ADDENDUM 1 – JOB 22957

TO: All prospective bidders on Projects IM-X-1-094(214)162, Job No. 22957 scheduled for the November 15, 2024 bid opening.

PLAN ADDENDUM SUMMARY AND APPROVAL

PROJECT INFORMATION		
Project:	IM-X-1-094(214)162	PCN: 22957
Location:	BURLEIGH CO; I-94, BISMARCK E TO E OF MENOKEN - EB	
Date:	11/7/24	Lead Designer: Apex Engineering Group
Bid Opening Date:	11/15/24	JOB#: 22957 Addendum#: 1

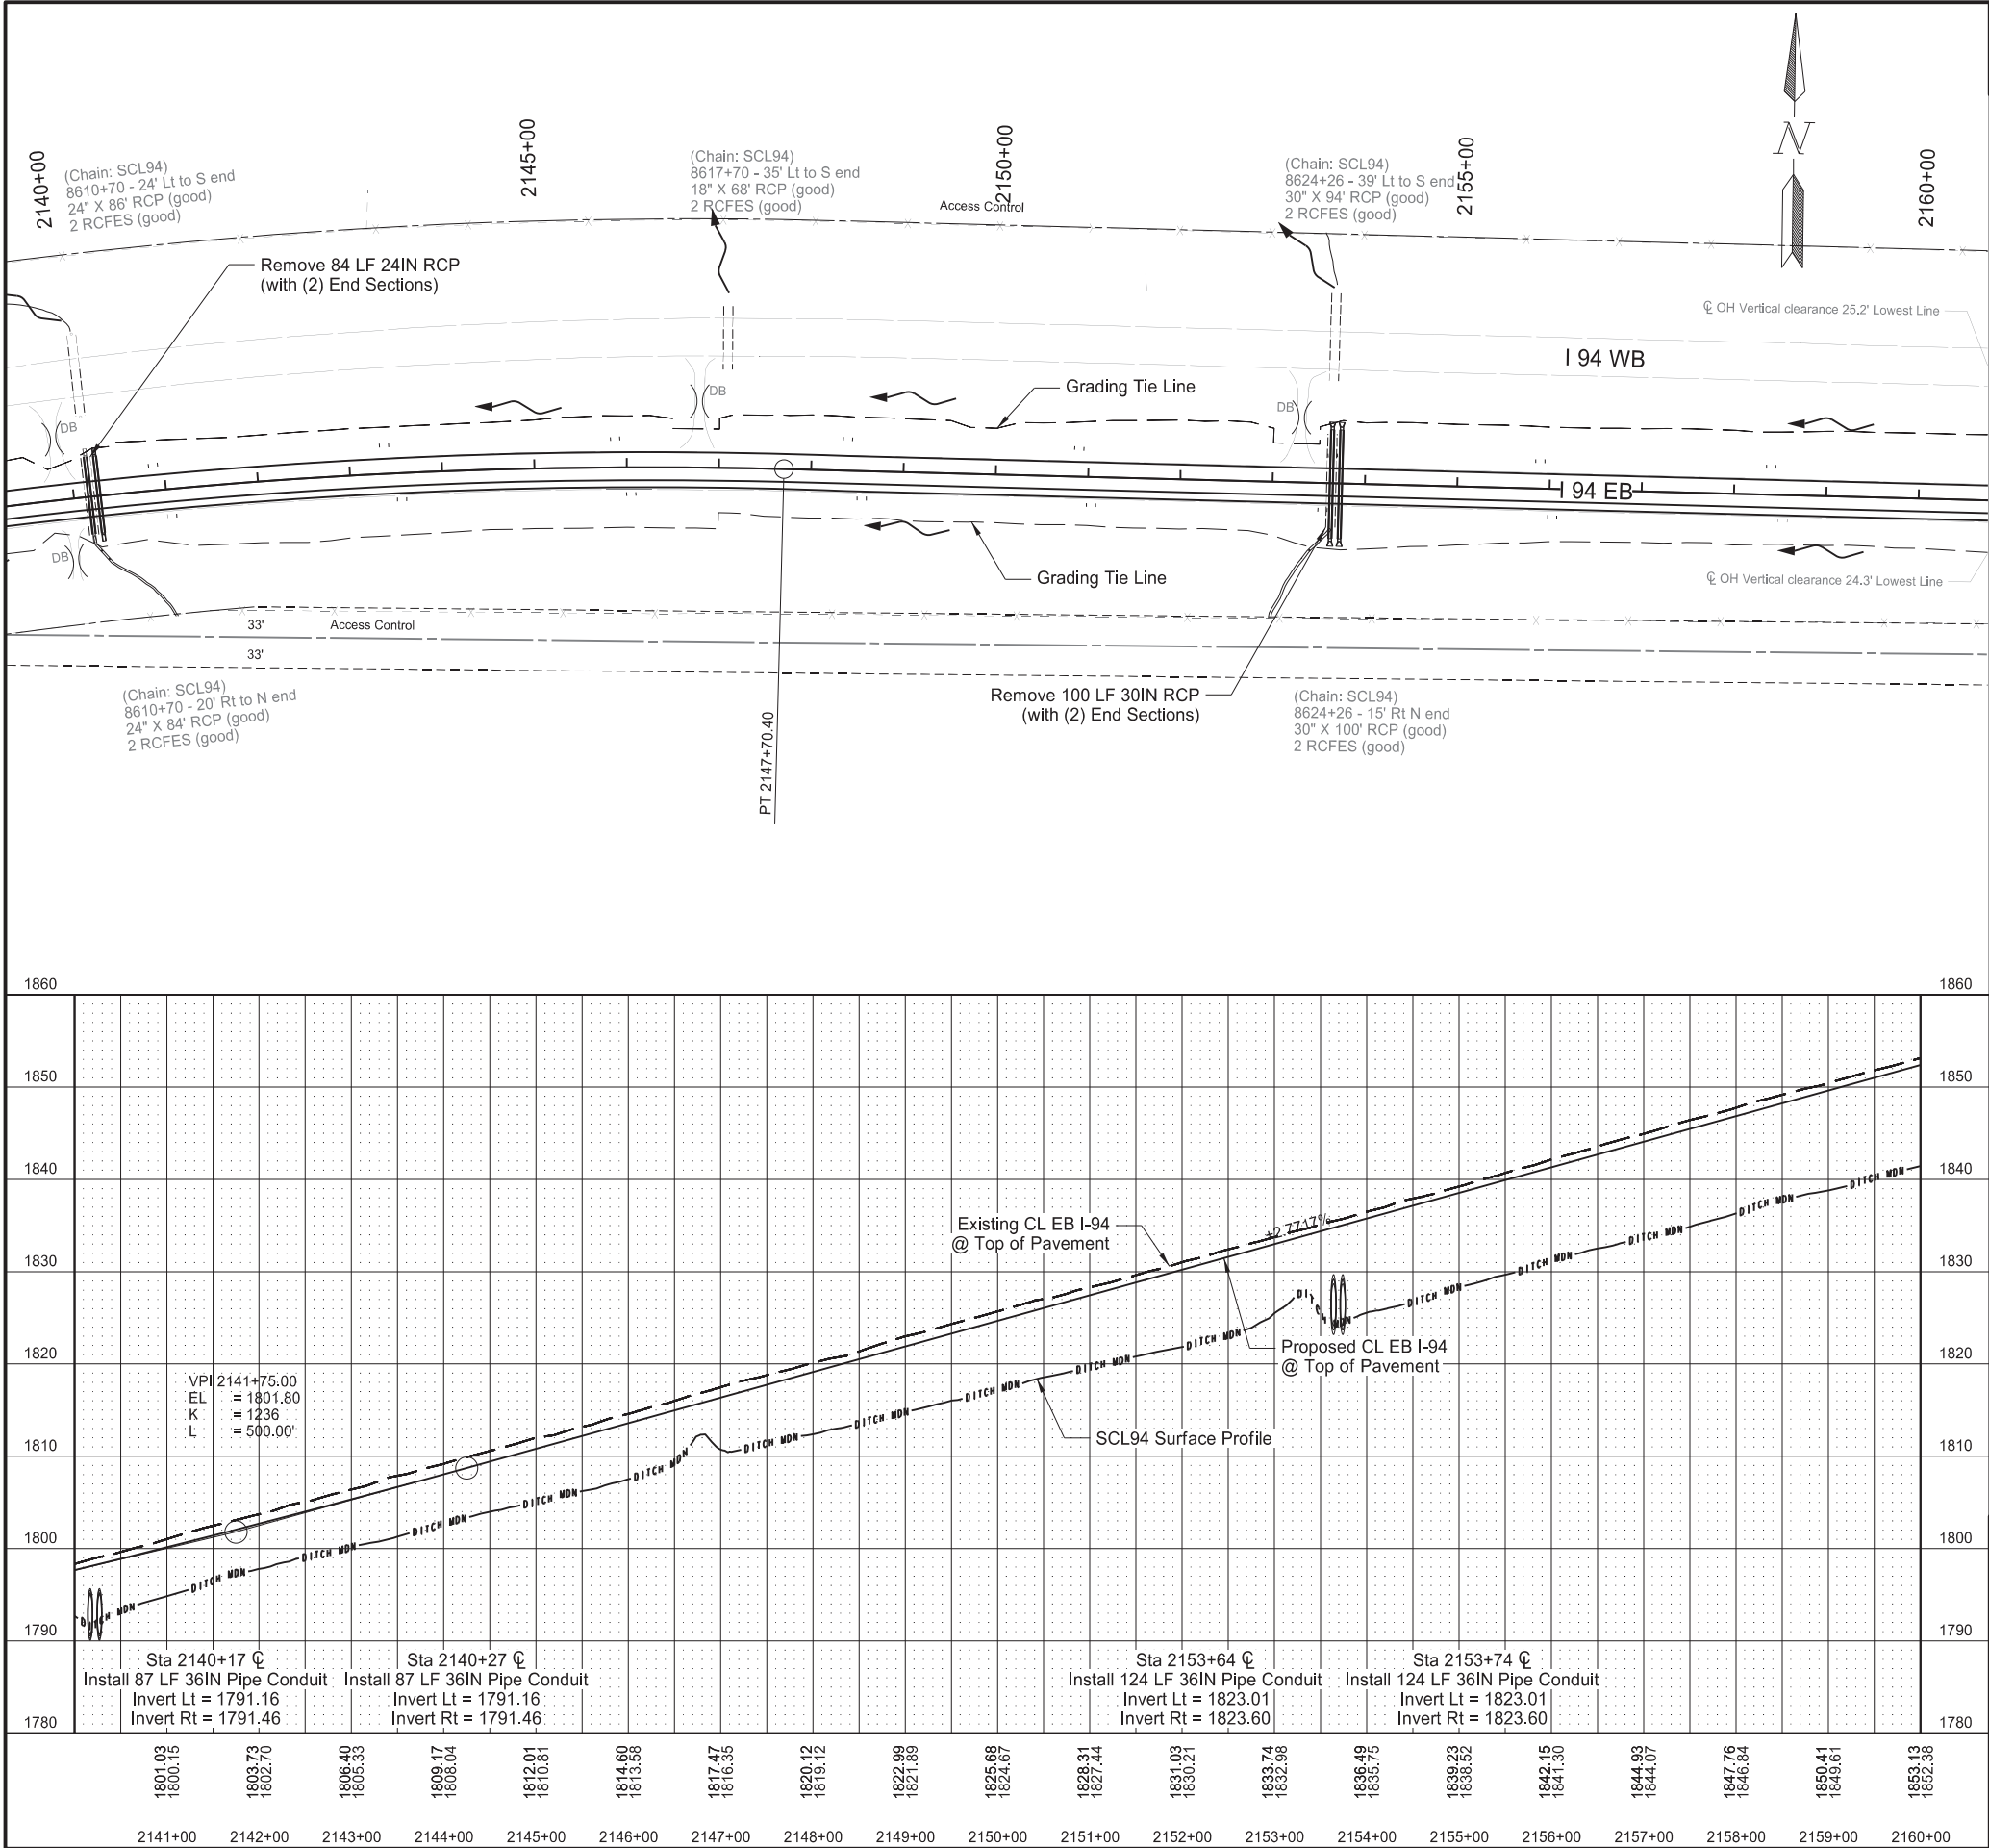
50	1	Revised hydraulic information on new pipes
51	1-2	Revised all pipe extensions to new pipe installations.
60	All	Reprinted sheets to show new culvert installations.
75	All	Reprinted sheets to show new culvert installations.
77	All	Reprinted sheets to show new culvert installations.
90	2-6	Revised dowel bar locations in plan view
100	1	Revised quantity for ATTENUATION DEVICE TYPE B-75, OBLITERATION OF PVMT MK and STATE FURNISHED MEDIAN BARRIER. Changed SHORT TERM 6IN LINE – TYPE NR to SHORT TERM 6IN LINE – Type R
100	10	Revised SHORT TERM 6IN LINE – TYPE NR to SHORT TERM 6IN LINE – Type R
100	11	Revised SHORT TERM 6IN LINE – TYPE NR to SHORT TERM 6IN LINE – Type R
100	19	Revised OBLITERATION OF PAVEMENT MARKING quantity and revised bid item and references for PVMT MK PAINTED 4IN LINE to PVMT MK PAINTED 6IN LINE
100	20	Added Pipe Work Area at STA 2110+07, Revised quantity for ATTENUATION DEVICE TYPE B-75 and STATE FURNISHED MEDIAN BARRIER

Revised	11/7/2024	STATE	PROJECT NO.	SECTION NO.	SHEET NO.
		ND	IM-X-1-094(214)162	200	144

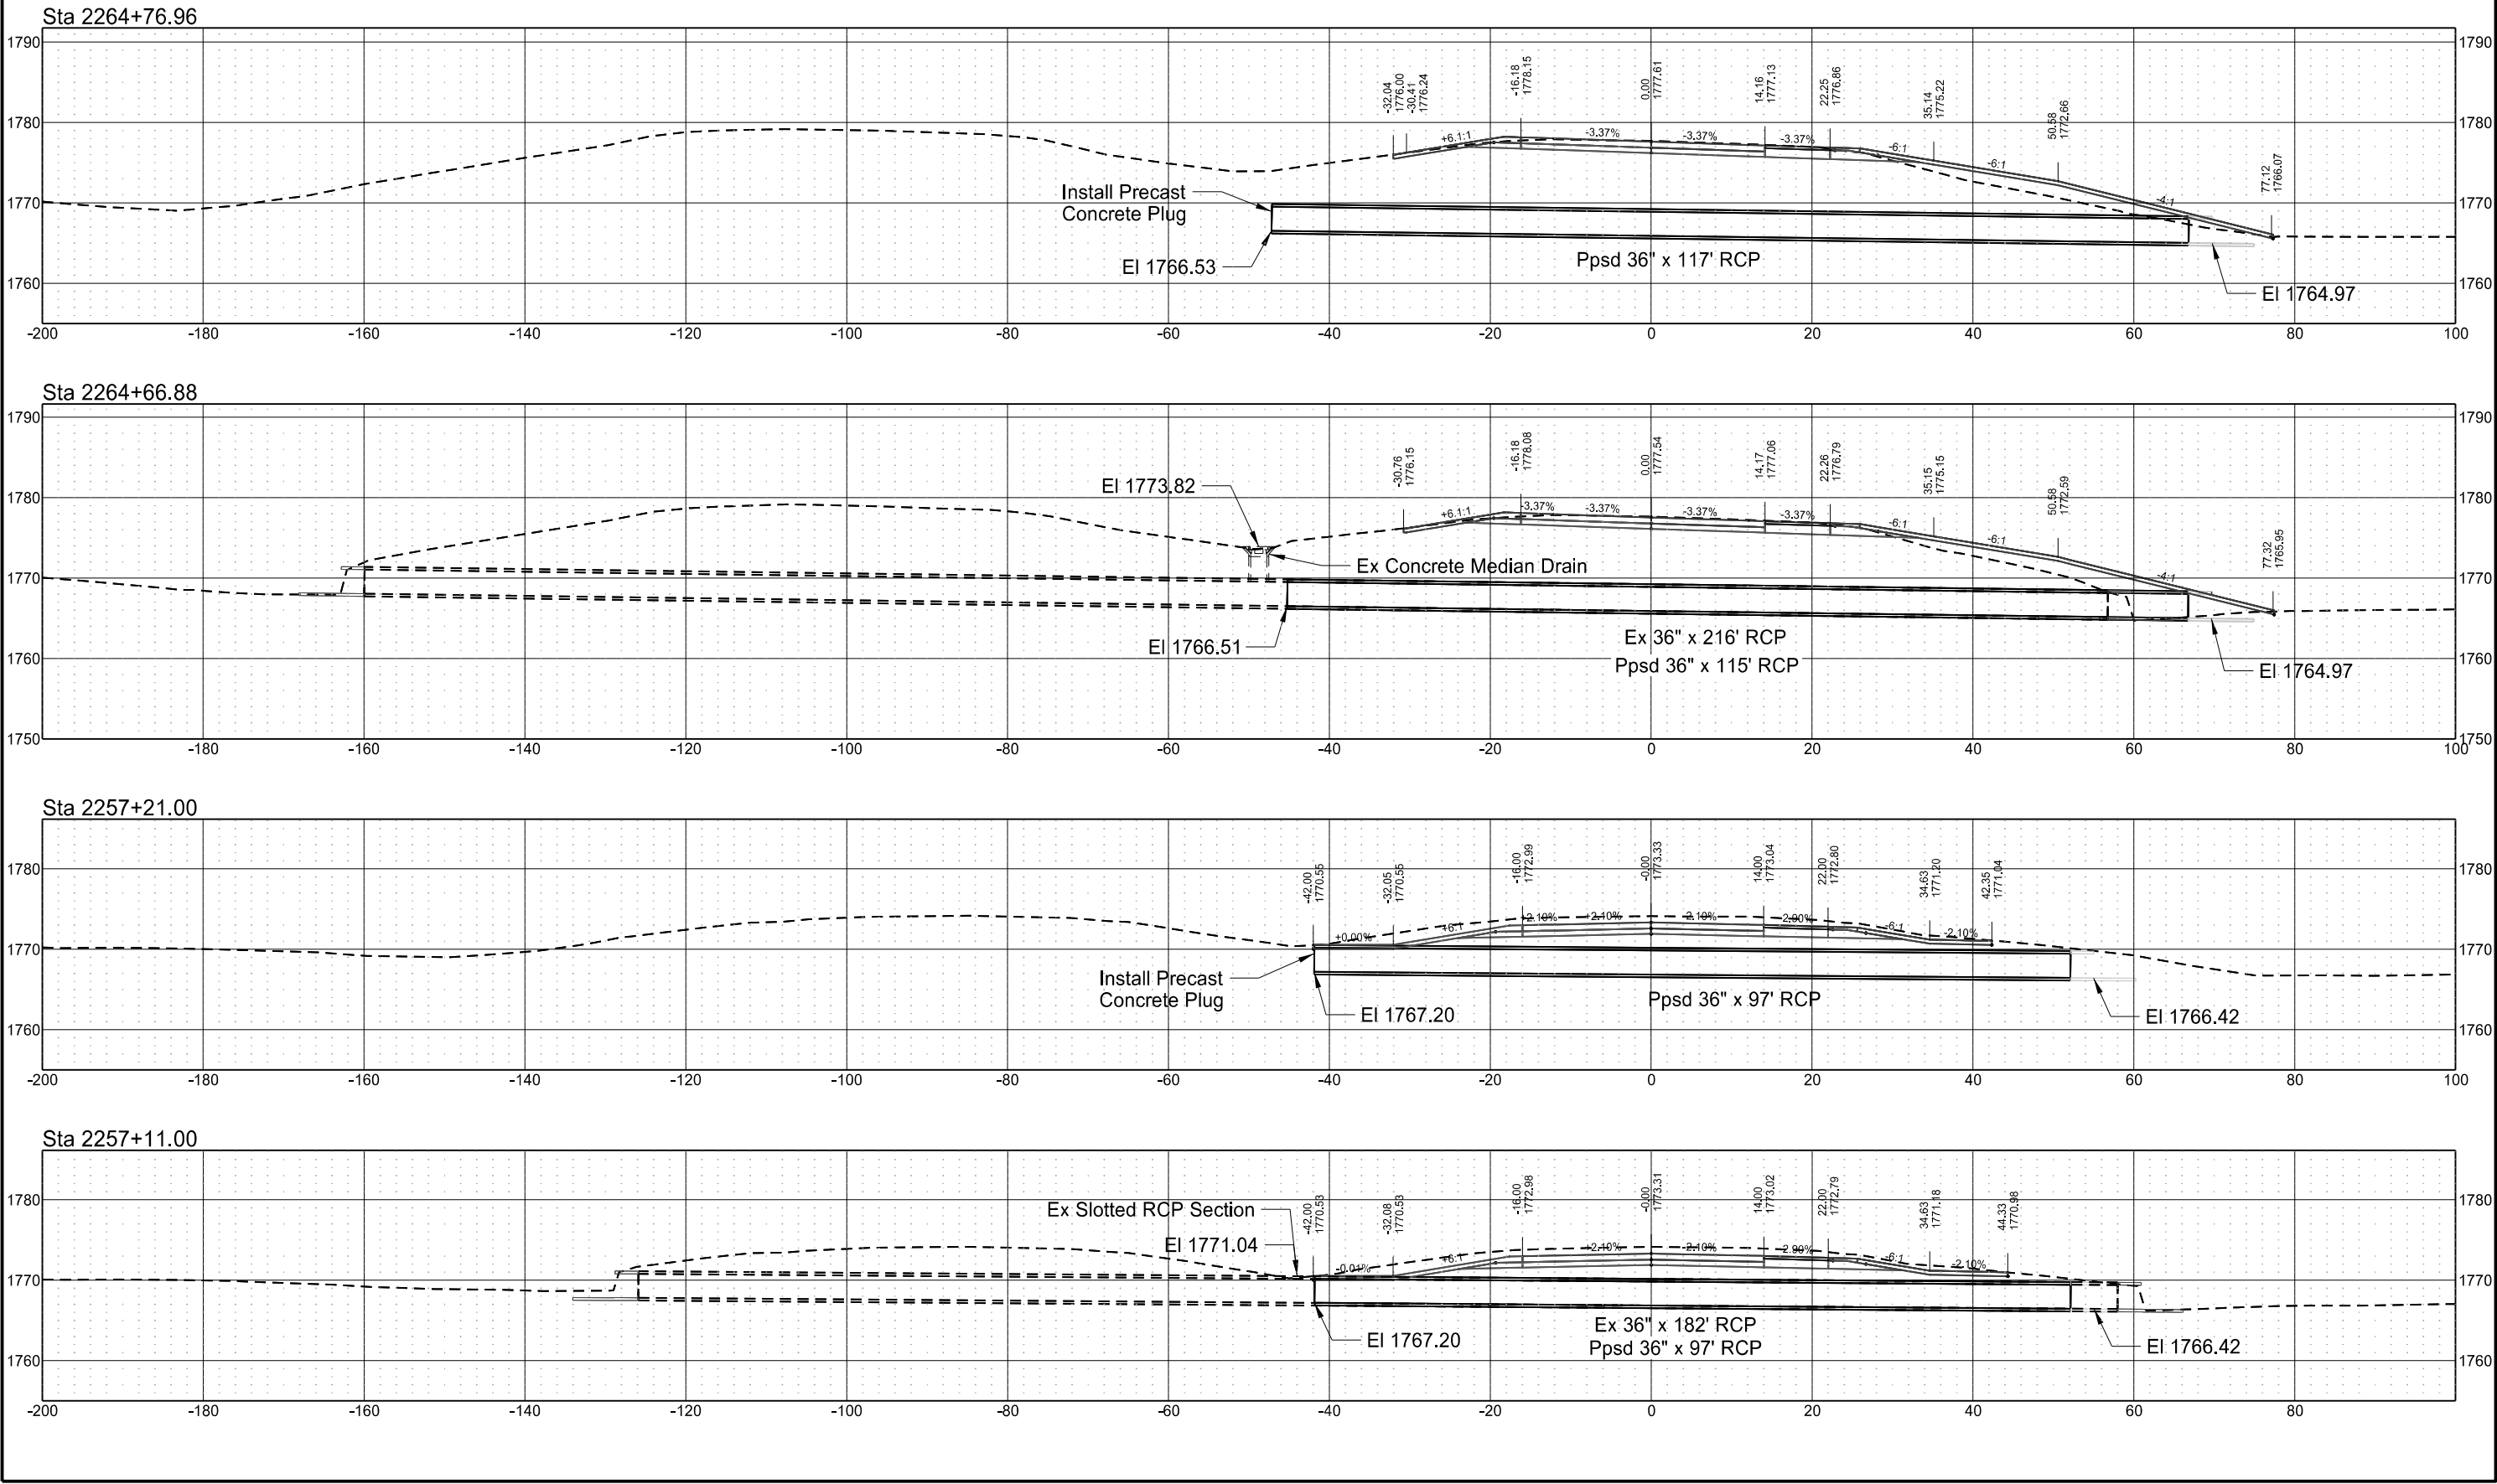
110	1	Revised quantities due to sign panel size changes
110	4	Sign 5 remove symbols and revised arrow
110	5	Sign 7 revised size
110	6	Sign 1 size changed & Sign 2 revised letter spacing
110	7	Sign 3 revised size Sign 4 revised border color, border thickness, and radius change Sign 5 removed symbols
110	8	Sign 6 revised border thickness and radius Sign 7 revised size
110	9	Sign 10 revised size and arrow Sign 11 revised size, border width, radius, and text size
200	139-153	Revised all pipe extensions to new pipe installations.
